Re: **121 E. Wilson Street – Alteration to Approved Plans**

121 E. Wilson Street

02/13/2023 URBAN DESIGN COMMISSION REVIEW

2 COURTYARD - SW ELEVATION - PREVIOUS
A252 1/16" = 1'-0"

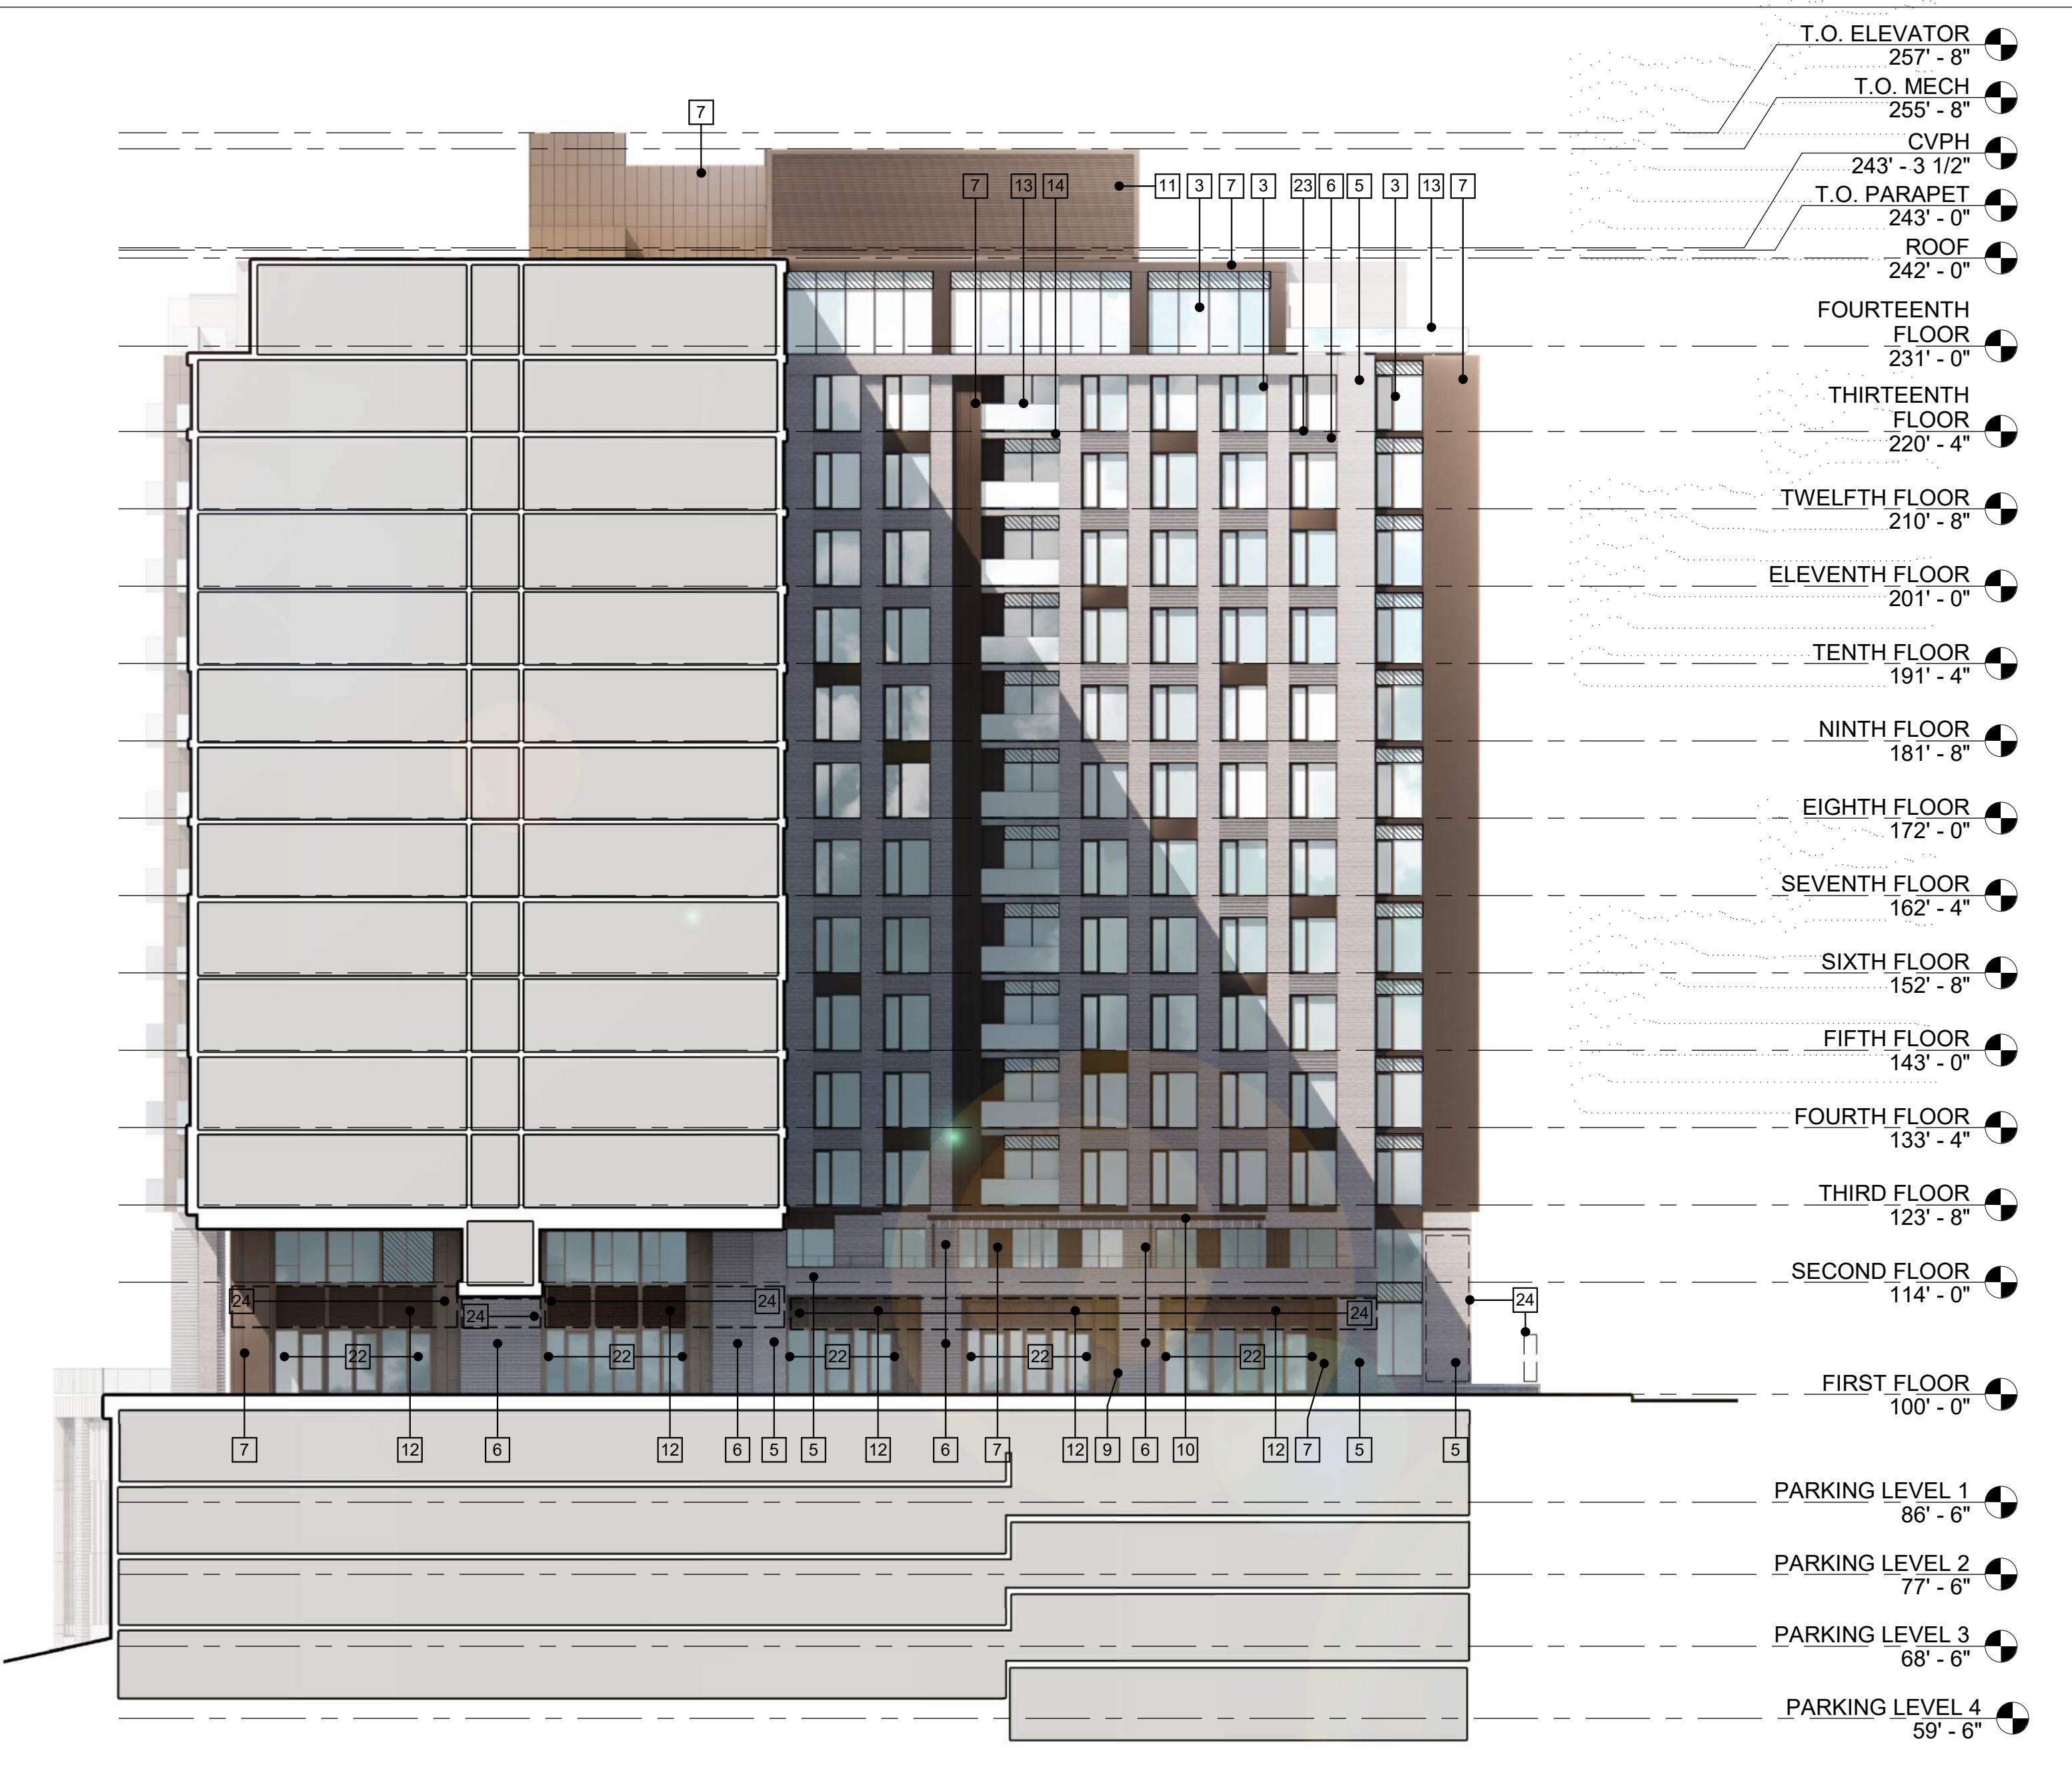
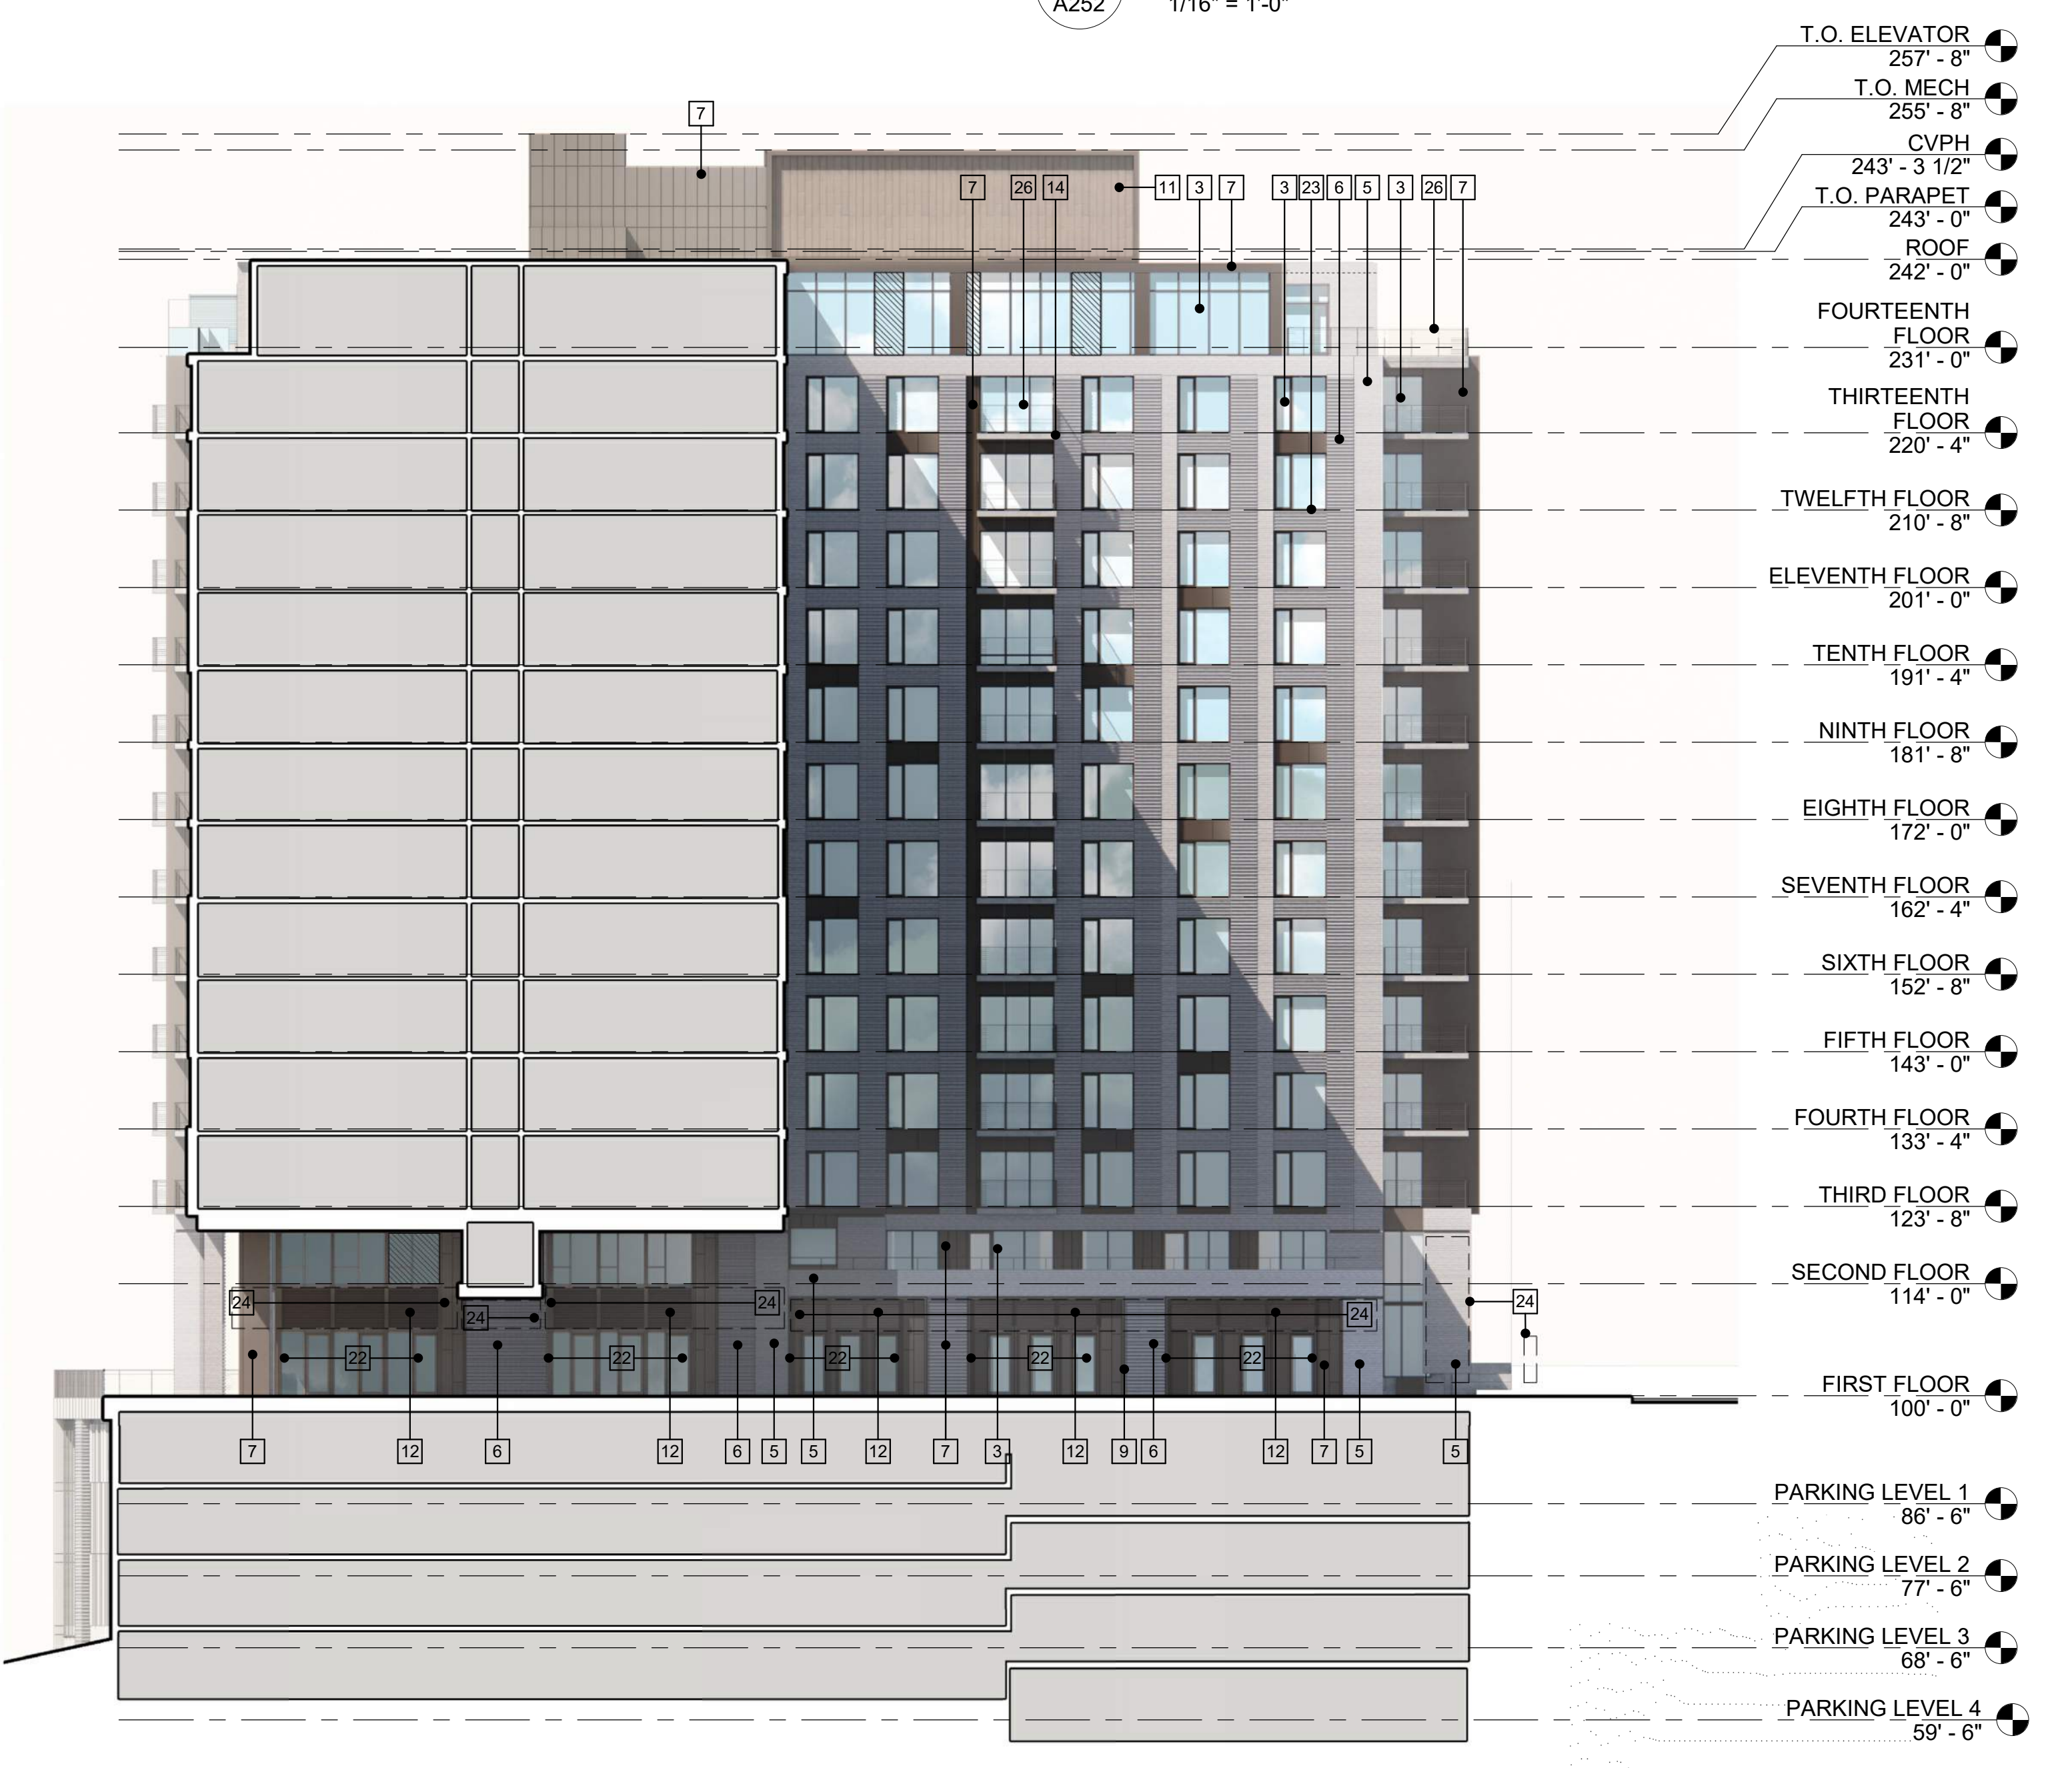
- In the updated design, the balconies facing the interior courtyard are extending out from the façade rather than inset into the building.
- The updated design removes a vertical element framing the inside facing balconies along the Wilson façade.
